Subject: Issuance of Amendment No.137 to Facility Operating License DPR-57  
- Edwin I. Hatch Nuclear Plant, Unit 1 (TAC 64786)

GEORGIA POWER COMPANY  
OGLETHORPE POWER CORPORATION  
MUNICIPAL ELECTRIC AUTHORITY OF GEORGIA  
CITY OF DALTON, GEORGIA  
DOCKET NO. 50-321  
EDWIN I. HATCH NUCLEAR PLANT, UNIT NO. 1  
AMENDMENT TO FACILITY OPERATING LICENSE

ATTACHMENT TO LICENSE AMENDMENT NO. 137

SAFETY EVALUATION BY THE OFFICE OF NUCLEAR REACTOR REGULATION

Figure 3.6-1 Pressure versus Minimum Temperature for Pressure Tests, Based on Surveillance Test Results

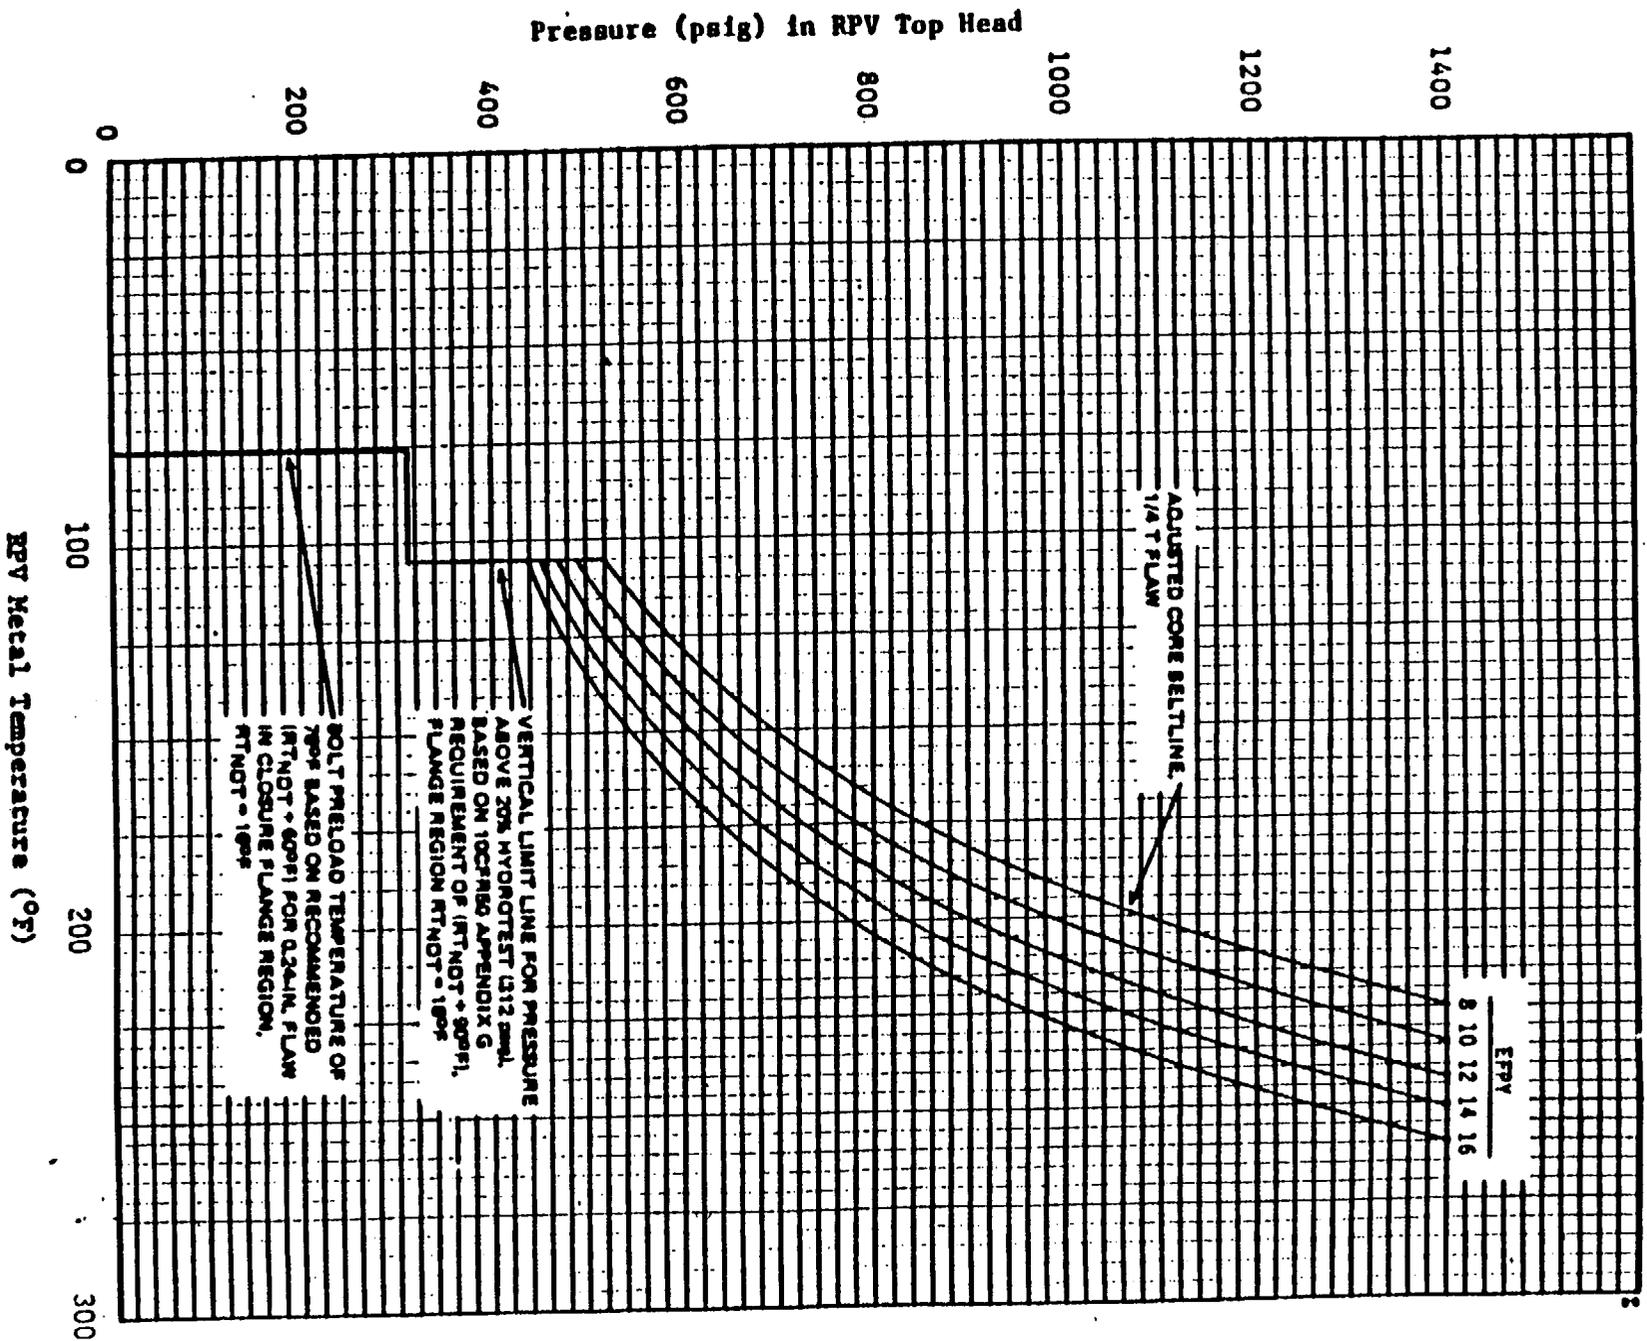
### 2.2 Revise TS Figure 3.6-1 to provide pressure/temperature limit curves for fluence values expected for 8, 10, 12, 14 and 16 EFPY of reactor operation.

The licensee proposed to refine Figure 3.6-1, "Pressure Versus Minimum Temperature for Pressure Tests, such as Required by ASME Section XI," to provide pressure/temperature limit curves for fluence values for 8, 10, 12, 14 and 16 EFPY. In addition to Figure 3.6-1, Figures 3.6-2, "Pressure Versus Minimum Temperature for Non-Nuclear Heatup/Cooldown and Low Temperature Physics Tests," and 3.6-3, "Pressure Versus Minimum Temperature for Core Critical Operation (Includes 40°F Margin Required by 10 CFR 50, Appendix G)", curves valid for 16EFPY were reviewed and evaluated. Our evaluation was documented in a memorandum to Daniel R. Muller from Gus C. Lainas, March 10, 1986 (Reference 2). We concluded that the curves were conservative and met the requirements of 10 CFR 50, Appendix G and H, ASTM E-185, Regulatory Guide 1.99, Revision 1, and Appendix G, Section III of the ASME Boiler and Pressure Vessel Code.

Figure 3.6-1 in the Technical Specifications provides conservative pressure/temperature limits for the performance of hydrostatic and pressure tests based on the anticipated fracture toughness of the reactor vessel. Currently the figure contains one curve, which is valid for 16 EFPY, estimated from the damage received by irradiation surveillance specimens after 5.75 EFPY. Since the measured fracture toughness shift in the surveillance plate exceeded the predicted shift of  $RT_{NDT}$ , using the methodology of Regulatory Guide 1.99, Revision 1, by a factor of 2.76, the predicted damage was increased by that factor in preparing the 16 EFPY curve.

The Spring 1987 Hatch Unit 1 outage was initiated after approximately 7.12 EFPY of reactor operation. As proposed by the licensee, the refined Figure 3.6-1 consists of a series of curves in 2 EFPY increments from 8 to 16 EFPY operation. The proposed curve for 16 EFPY is the same pressure/temperature curve previously reviewed and evaluated by the staff (Reference 2).

The purpose of adding the series of curves from 8 to 16 EFPY is to eliminate conservatism in the pressure/temperature limits and permit hydrostatic and pressure tests to be performed at lower temperatures, which will require less recirculation pump heatup time. It is planned to use the 8 EFPY curve for the Spring 1987 test. No change is proposed for Figures 3.6-2 and 3.6-3 in the Technical Specifications.

The proposed change to Figure 3.6-1 of the Technical Specifications of Hatch Unit 1 is essentially administrative and allows hydrostatic and leak testing to be performed with the minimum amount of heat stored in the reactor coolant to meet the reactor vessel nil-ductility requirements. As the pressure/temperature limits meet the requirements of 10 CFR 50, Appendixes G and H, ASTM E185, Regulatory Guide 1.99, Revision 1, and Appendix G, Section III of the ASME Code, we find the proposed change to be acceptable.
